**Carmel Plan Commission
COMMITTEE
Tuesday, October 1, 2024 Department Report**

1. Docket No. PZ-2024-00028 PUD: Towne 146 PUD Rezone

2. Docket No. PZ-2024-00099 DP/ADLS: Spring Mill Shops

3. **Docket No. PZ-2024-00122 CA: Meridian Trails Commitment Amendment**
4. **Docket No. PZ-2024-00123 V: Meridian Trails Height Variance**
5. **Docket No. PZ-2024-00130 V: Meridian Trails Parking Variance**

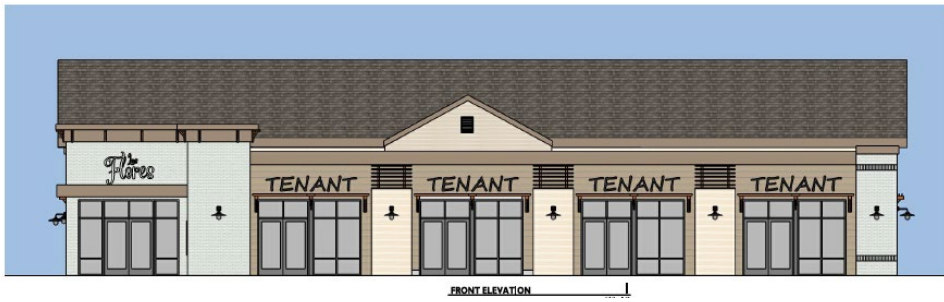
- For example, below in the left image (from conceptual drawings), the blue portion of the building looks like one complete section under the pitched roof (see red dashes). In the center image, the area under the pitched roof has many different parts and design elements. It does not appear to be "connected" to the roof style above it.

- Similarly, there are some parts of the building where dormers (on the pitched roof) are located have no connection or relation to the portion of the building below it. (See image above on the right.) **Staff would like to see some more continuity.**
- Section 2.3 of Exhibit F states that "Buildings abutting Spring Mill Road shall have finished facades facing Spring Mill Road." **The facades have matching building materials but lack interest and appear very much like the back of a building.** No windows are provided, only a door. See image above on right.
- **There is also concern with visibility of the rooftop AC units located on the flat roof portions of the building. How tall is the parapet? Please provide a section view.**
